UNITED STATES PATENT AND TRADEMARK OFFICE

APPLICATION NO.	FILING DATE	FIRST NAMED INVENTOR	ATTORNEY DOCKET NO.	CONFIRMATION NO.
10/714,225	11/14/2003	Michael W. Mullaney	42620.17	2542
7590 Dustin T. Johnson Haynes and Boone, LLP Suite 700 2323 Victory Avenue Dallas, TX 75219		07/08/2010	EXAMINER SEVILLA, CHRISTIAN ANTHONY	
			ART UNIT 3775	PAPER NUMBER
			MAIL DATE 07/08/2010	DELIVERY MODE PAPER

Office Action Summary

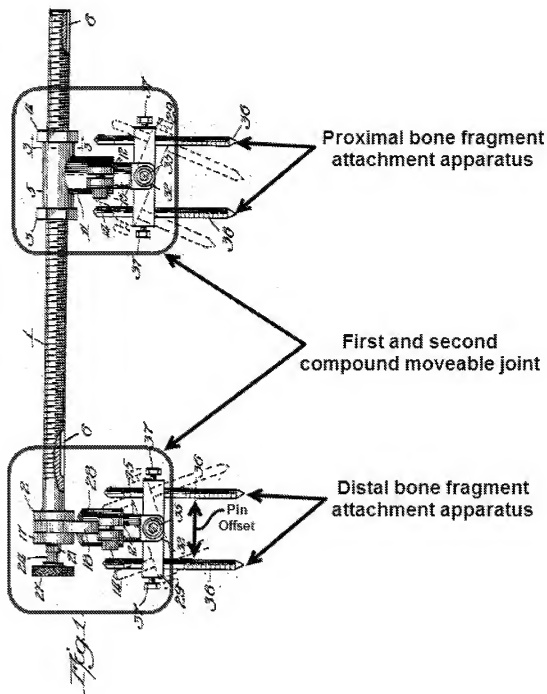
Regarding claim 8, Ettinger discloses a) characterizing a mounting condition for a proximal bone fragment attachment apparatus (36) and a distal bone fragment attachment apparatus (36), as shown in annotated Fig. 1 above; b) determining a first

Regarding claim 9, Ettinger discloses the deformity-correcting fixator comprises a unilateral fixator including a first and a second compound movable joint, as shown in annotated Fig. 1 above, wherein each compound movable joint provides deformity correction in two degrees of freedom, and a strut assembly, and a strut assembly which provides a third degree of freedom for each compound movable joint.

Regarding claim 12, Ettinger discloses parameters for offsets and joint rotations {zero values if they do not exist} of joints and clamps {e.g., the first and second compound moveable joints in annotated Fig. 1 above}.
